TO: Madeleine Reinke, Kimley-Horn and Associates, Inc.
FROM: Cynthia Thye, Planner 1
DATE: December 31, 2025
SUBJECT: SP25-119: Lincoln Professional Park L2 - 7 Brews Coffee – Site Plan
Review Comments 02

LINCOLN PROFESSIONAL PARK FILING NO. 1
LOT 2, PARKER, CO
7 BREW - SITE PLAN
COVERSHEET

sheet contents:
TRASH ENCLOSURE

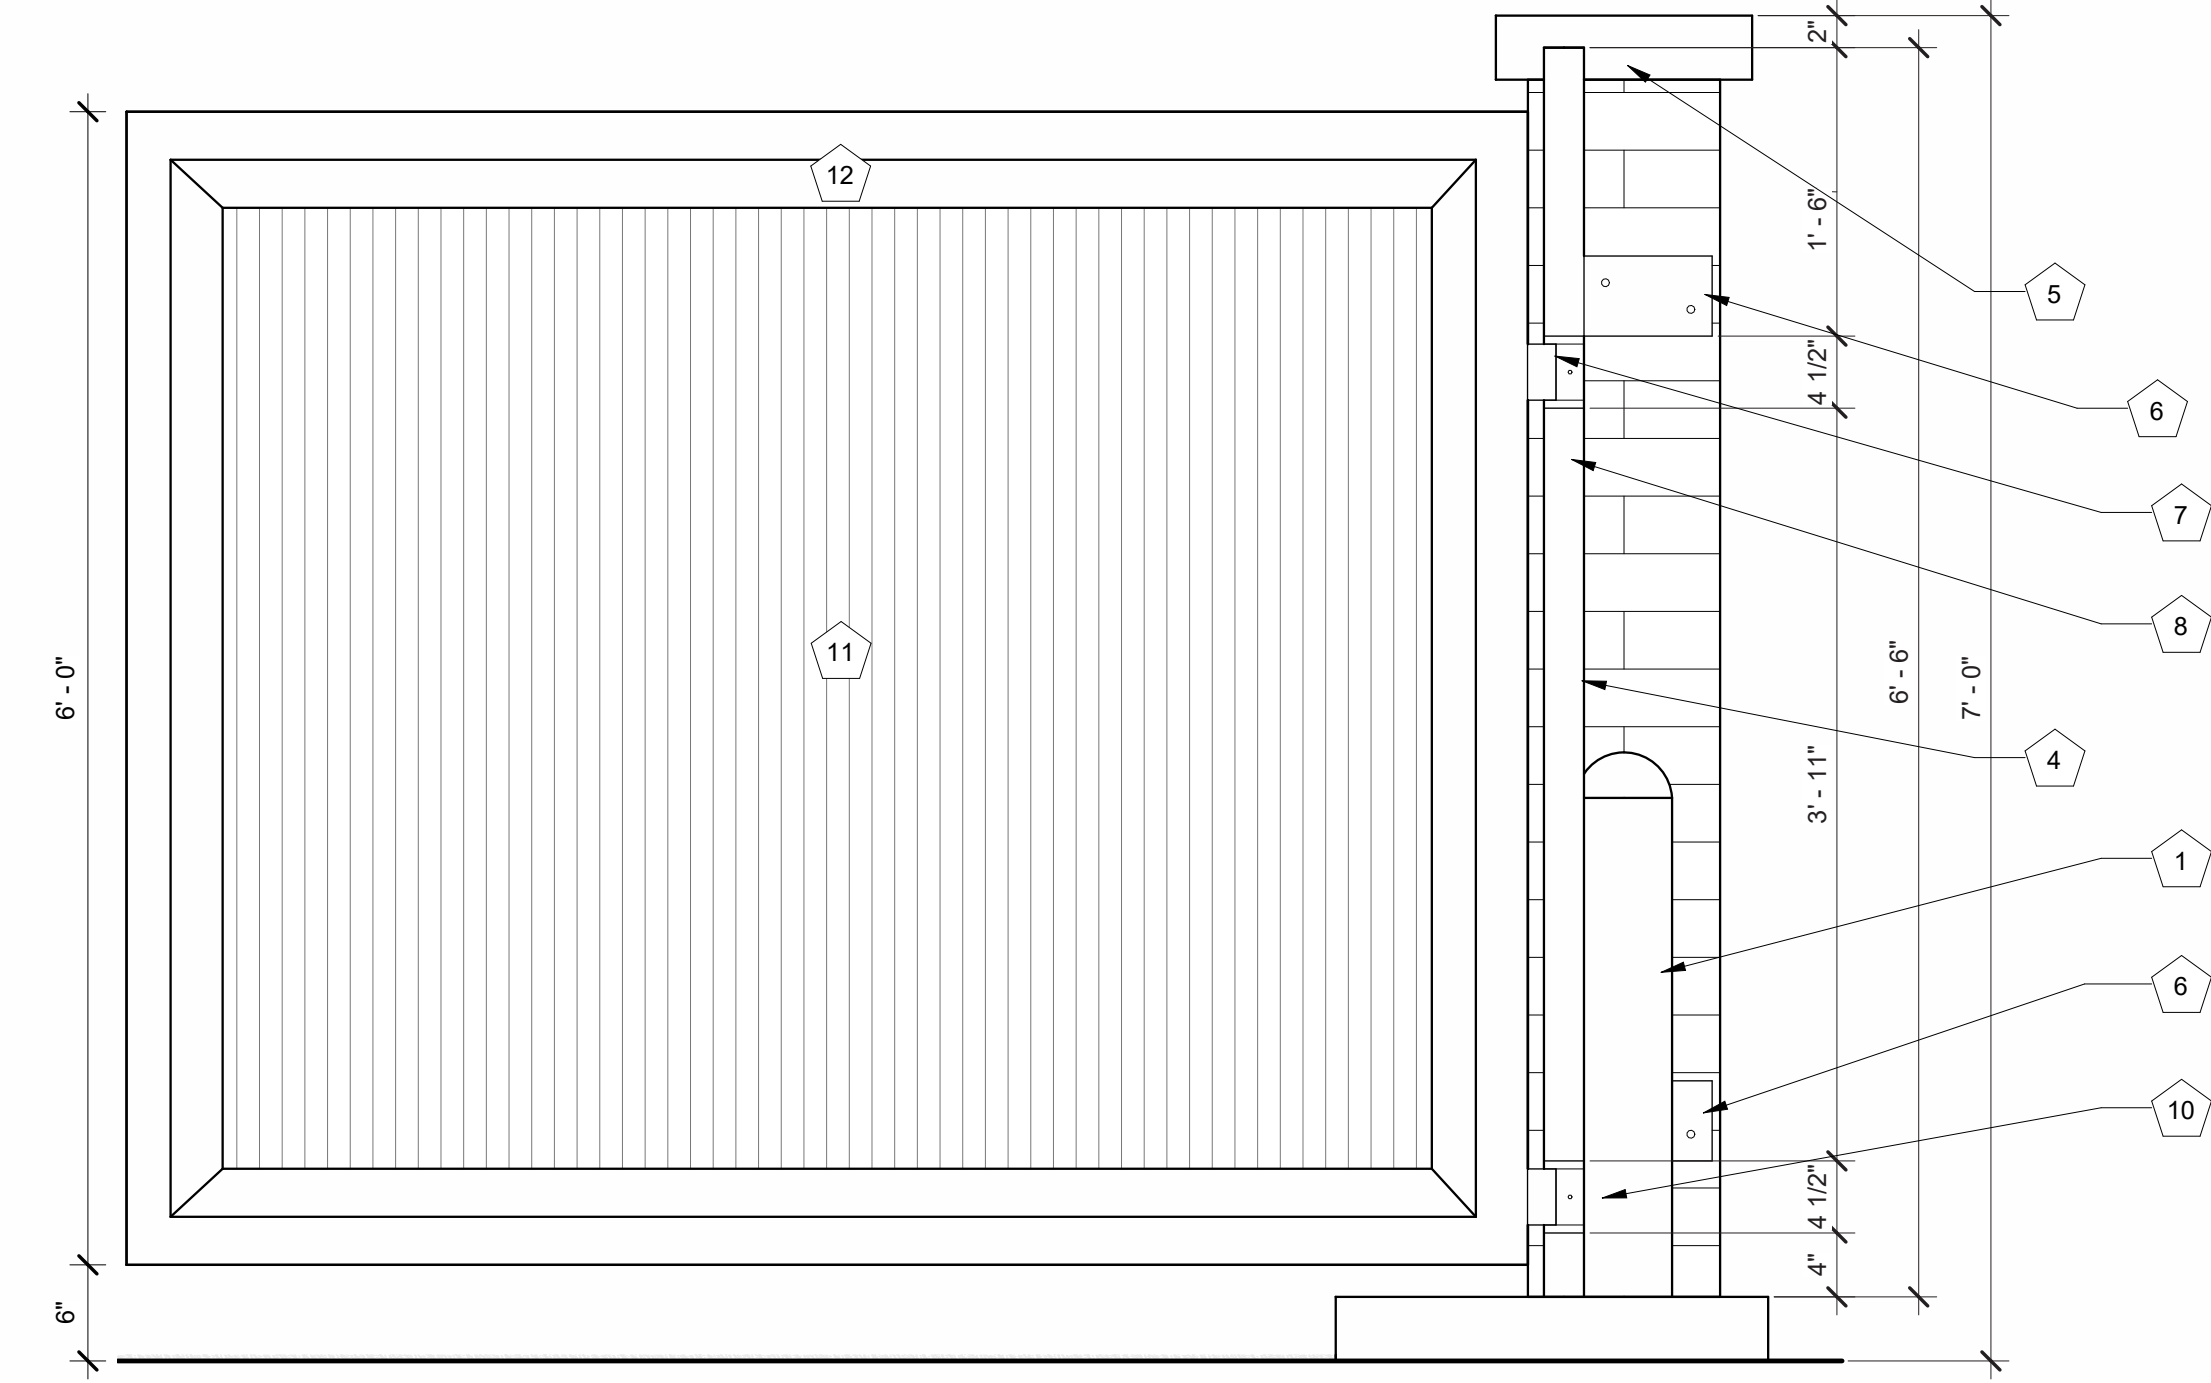
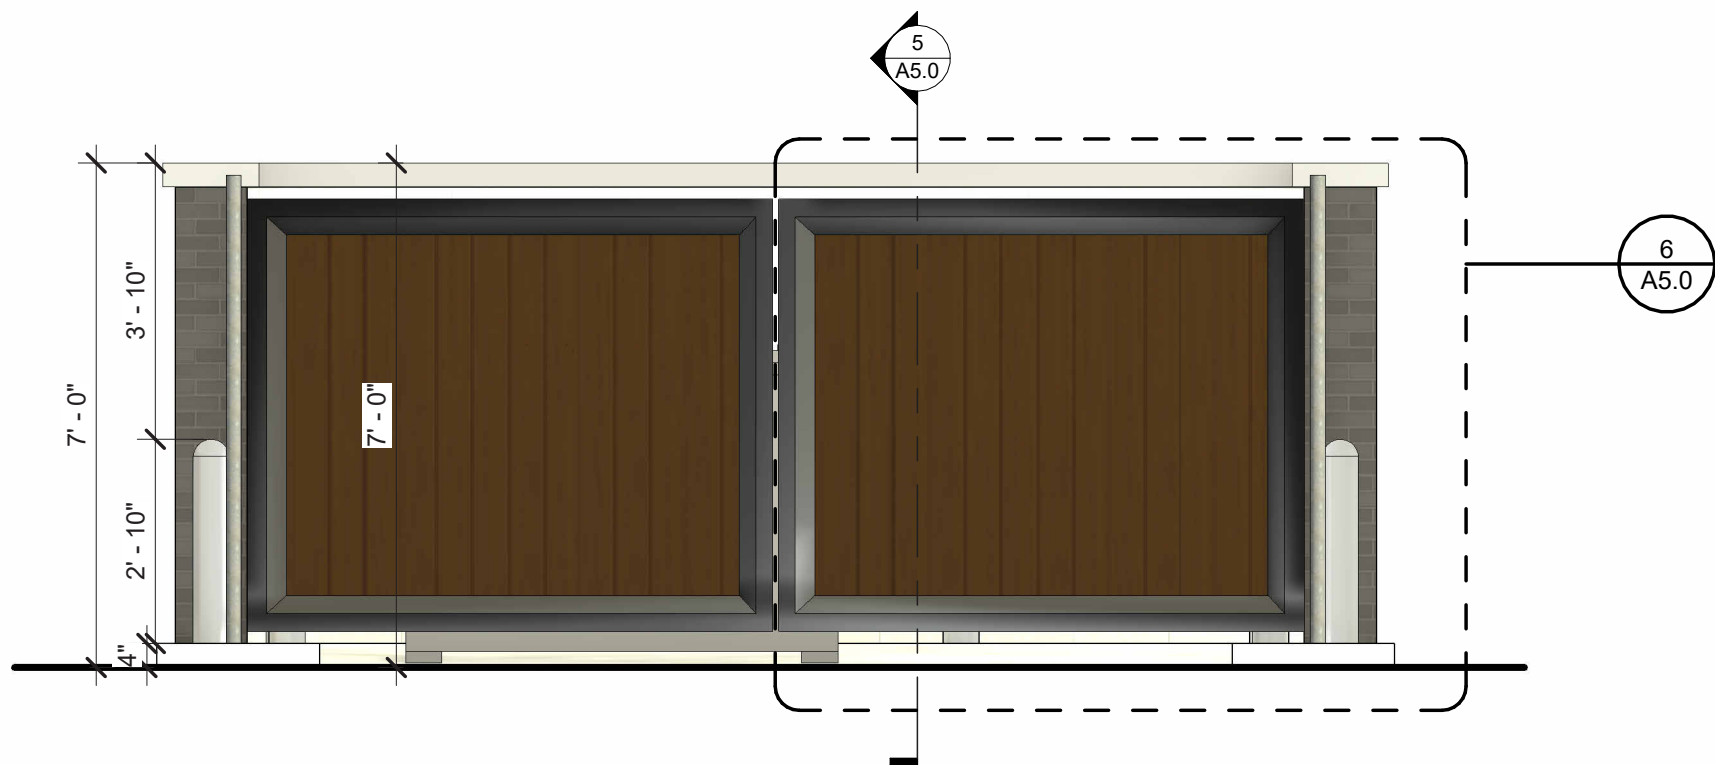
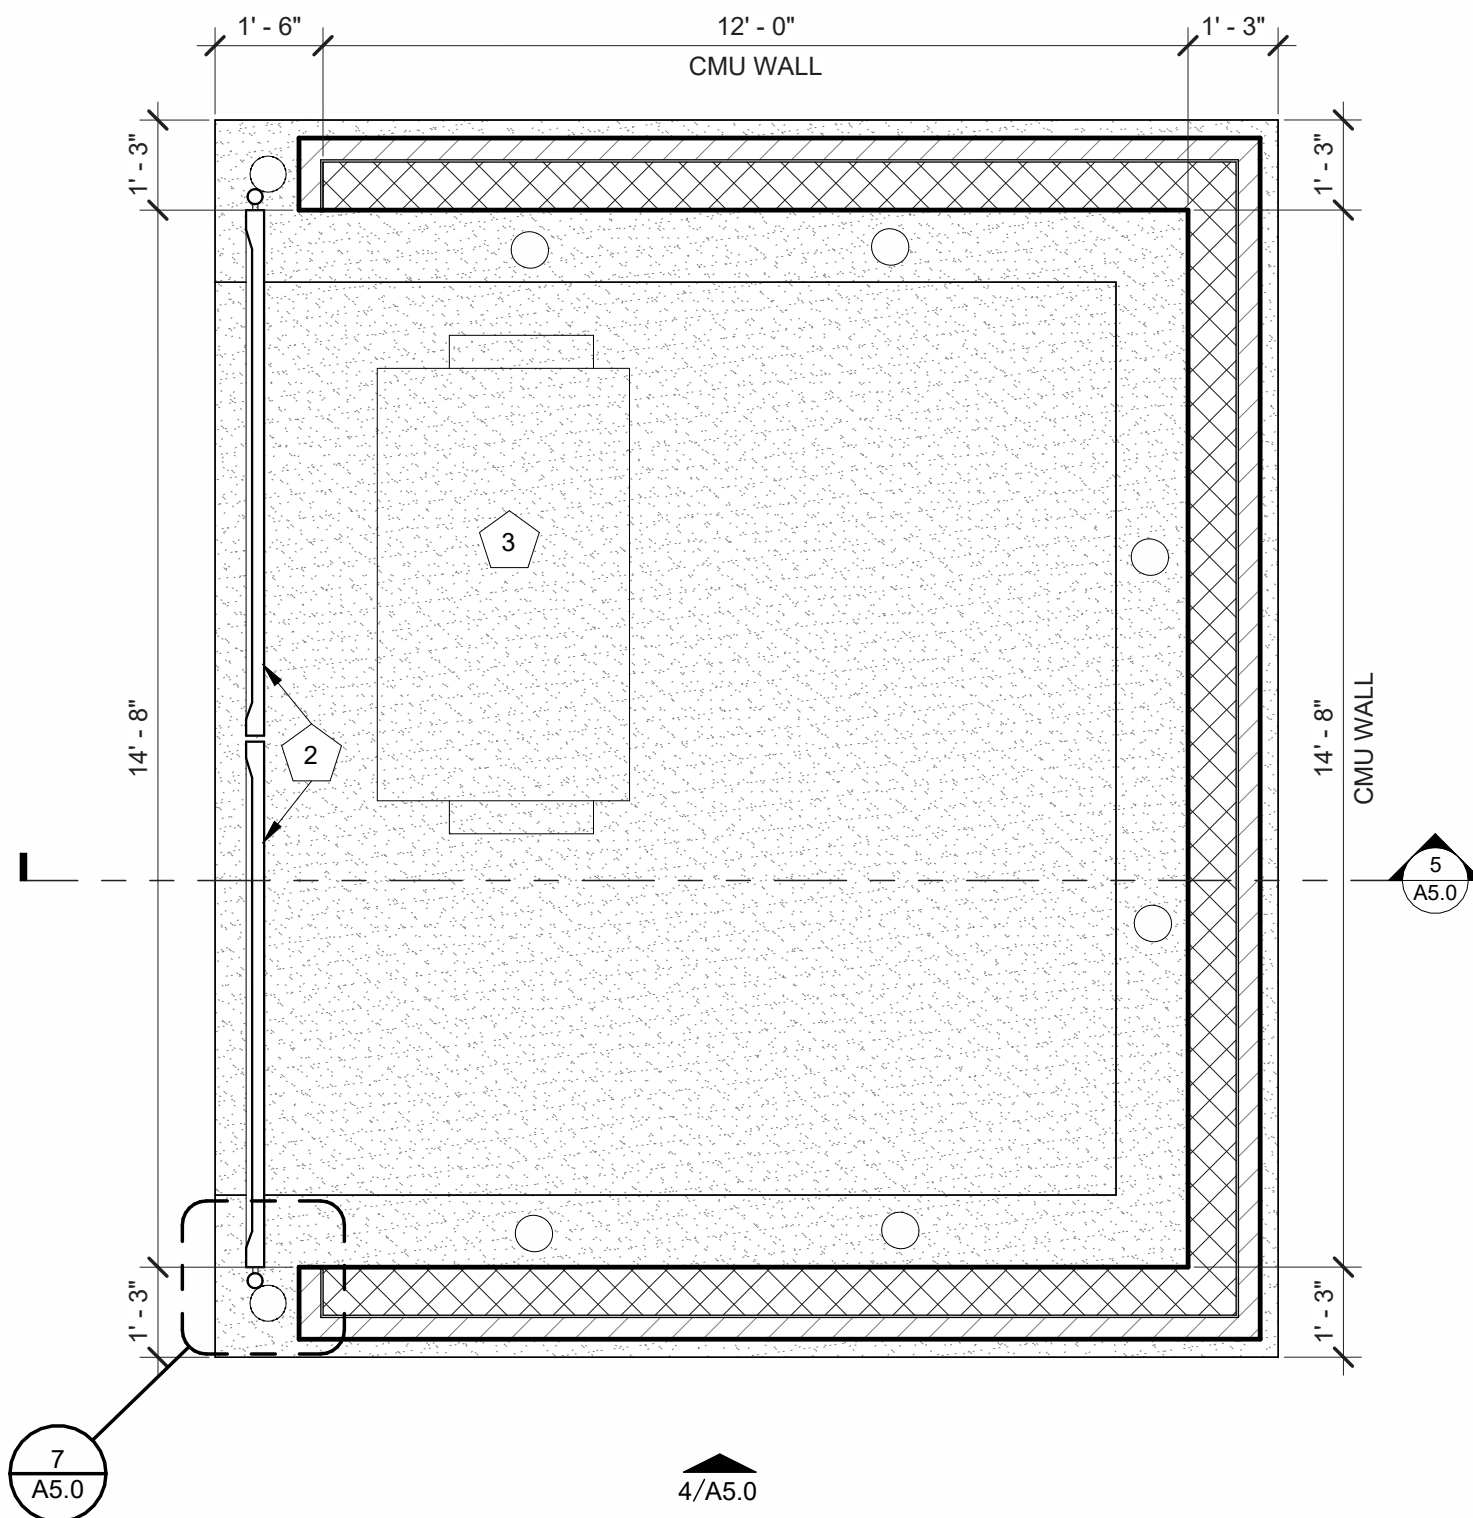
Revise trash enclosure doors to steel painted to match primary structure. For maintenance and durability, these doors will wear easily.

DRAWING TITLE:
PHOTOMETRIC SITE PLAN

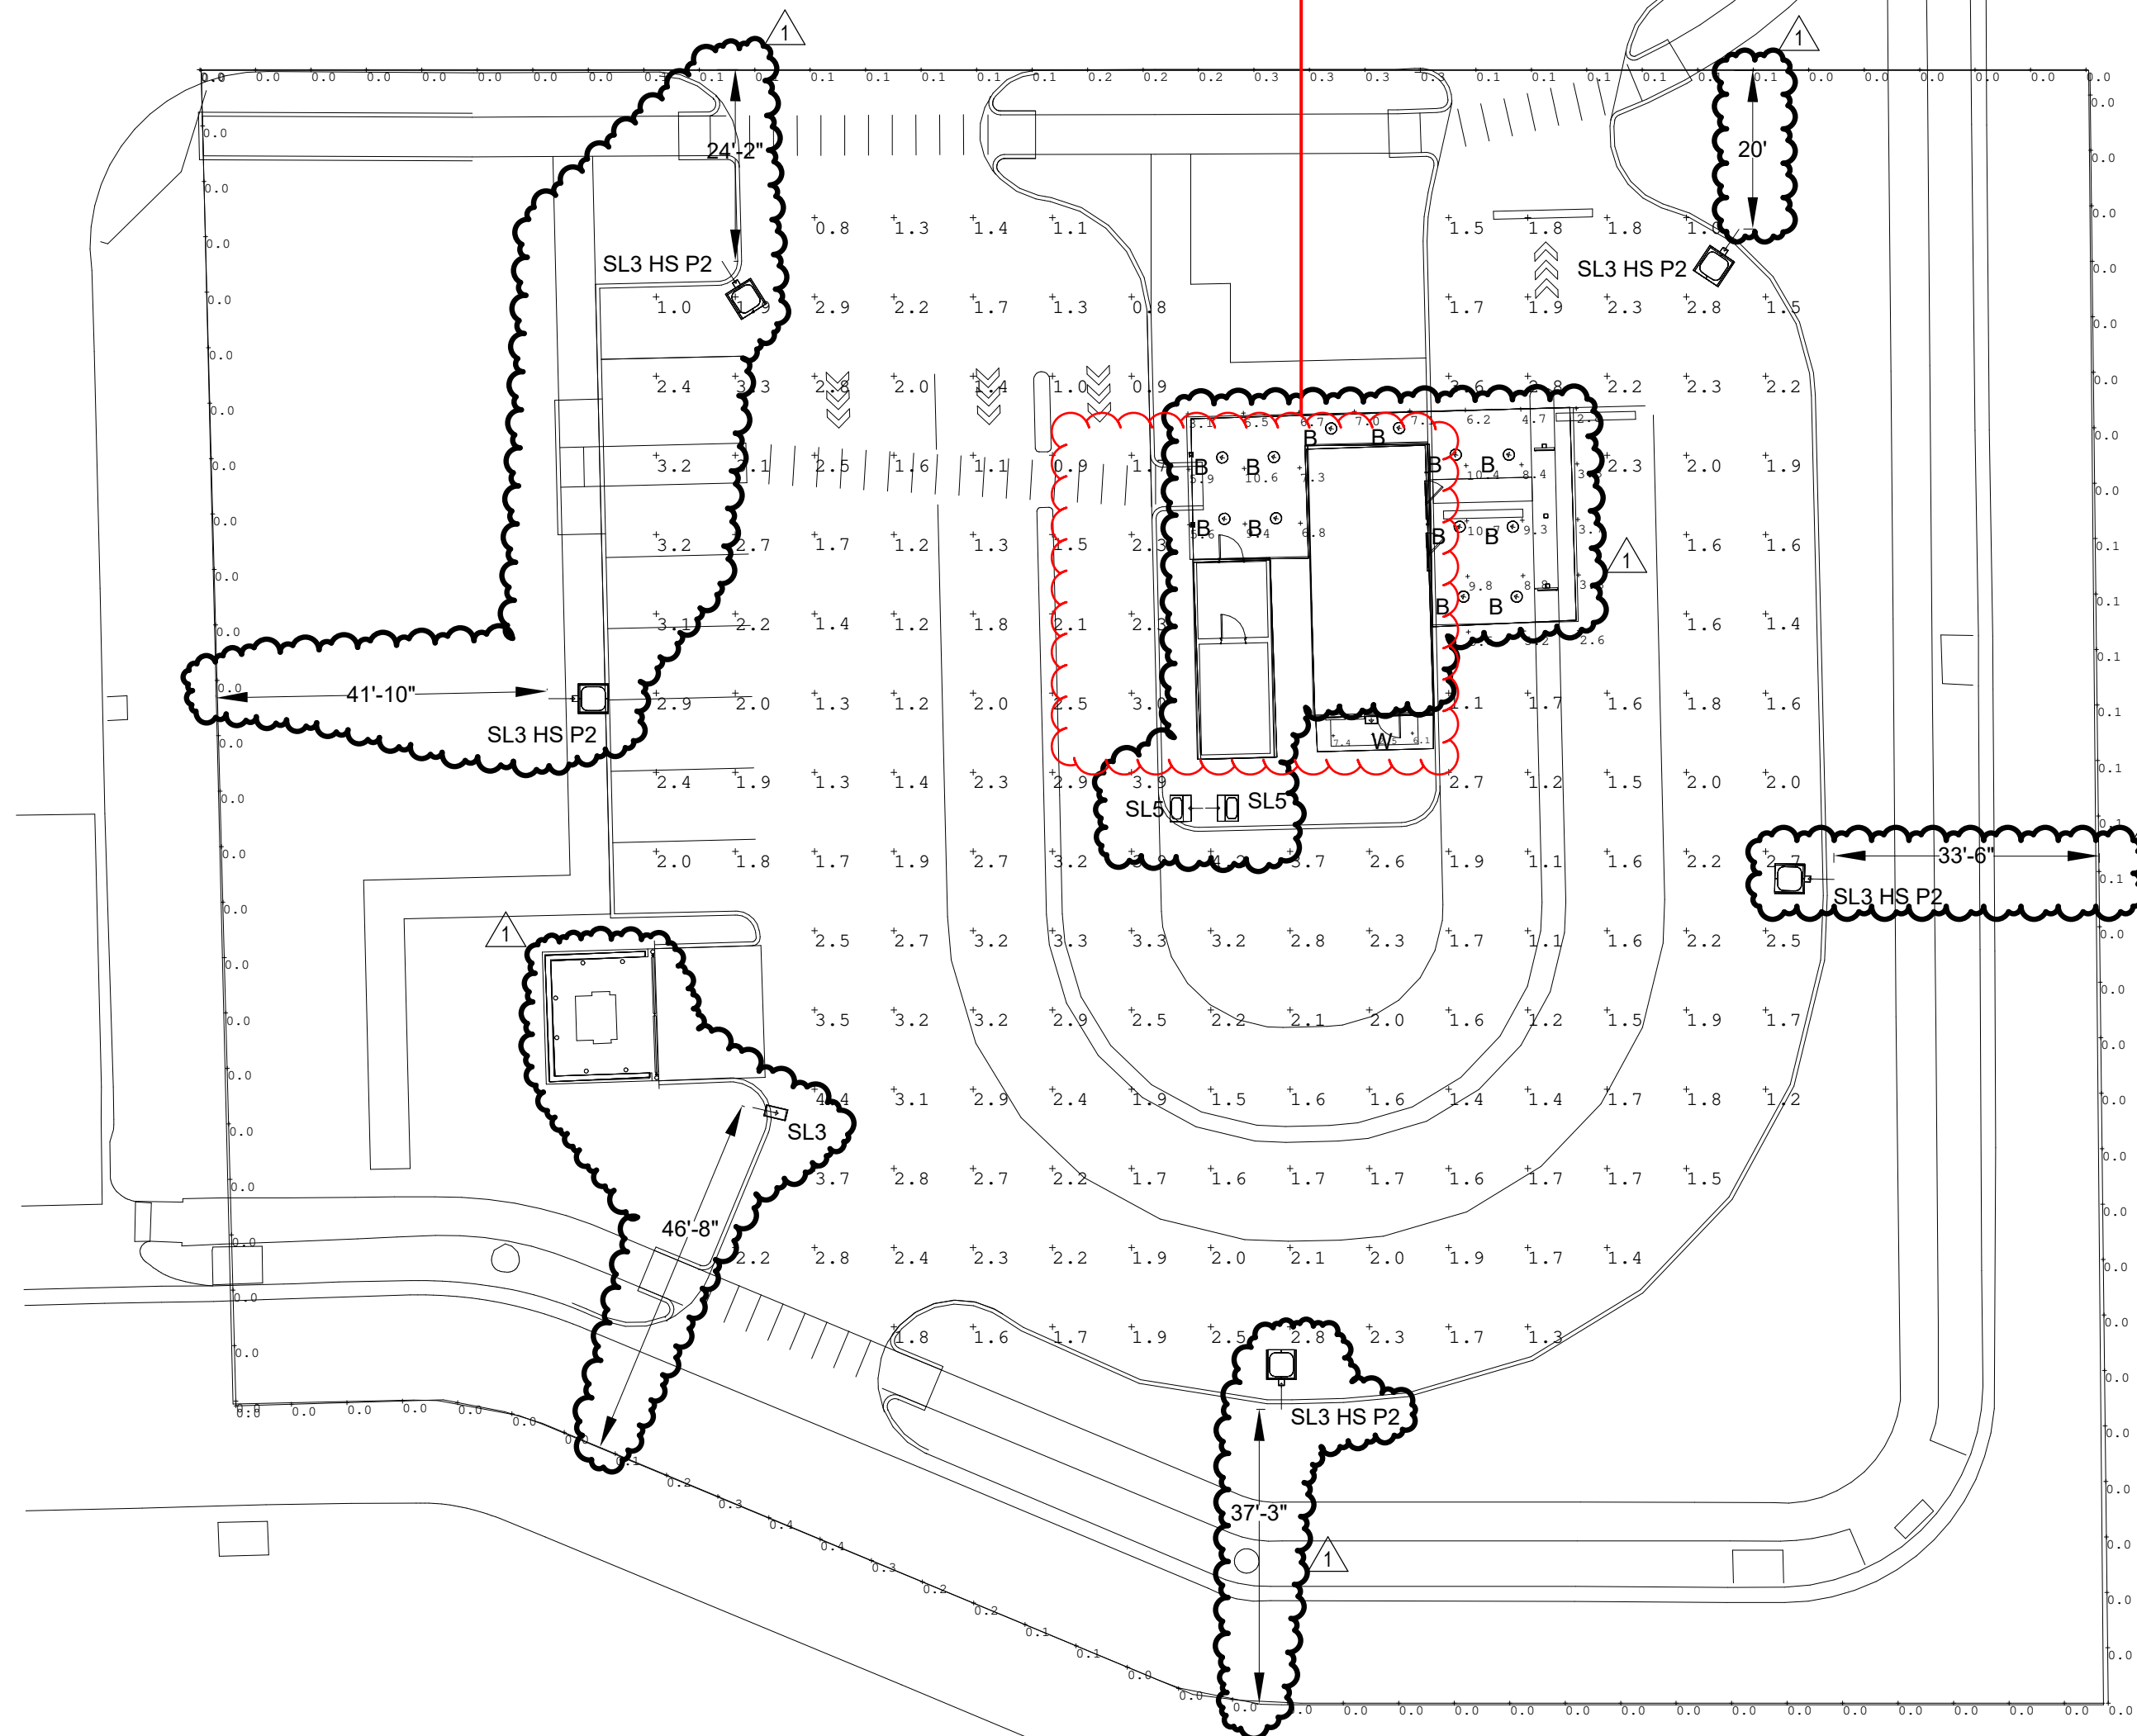
Revise to match updated site plan sheet 3, where main building is adjacent to cooler.

Add correlated color temperature of each fixture per LDO 13.08.110(e)(2).a. must be below 5001 degrees Kelvin.

Add color of each fixture. Unless on ceiling of canopy need to be black or bronze.
